JSD-80 Personality Module Bulletin

This bulletin is to address a recent batch of faulty memory modules on the JSD-80 control card.

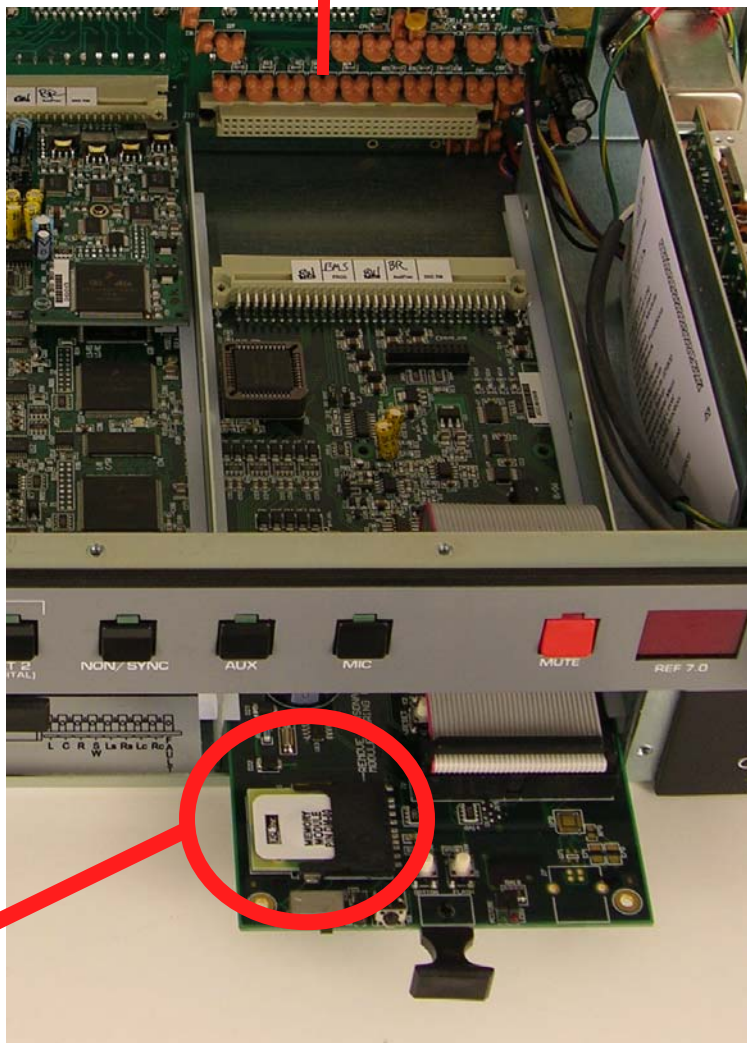
The faulty module can cause the JSD-80 to power cycle and remain in this operation until the module is removed.

The modules were tested in QC but we believe that moisture/flux from the assembly process is causing the modules to fail over time. We have contacted our board manufactures and advised on refining the process to eliminate the problem for all future builds.

For now the best and safest solution would be to remove the modules from all units with a serial number greater than JSD-80-04000 or any affected units with the symptom described above.

We also recommend writing the serial number of the JSD-80 onto the module and attaching it to the JSD-80 for later use.

1. Remove the control card from the JSD-80

2. Remove this Module
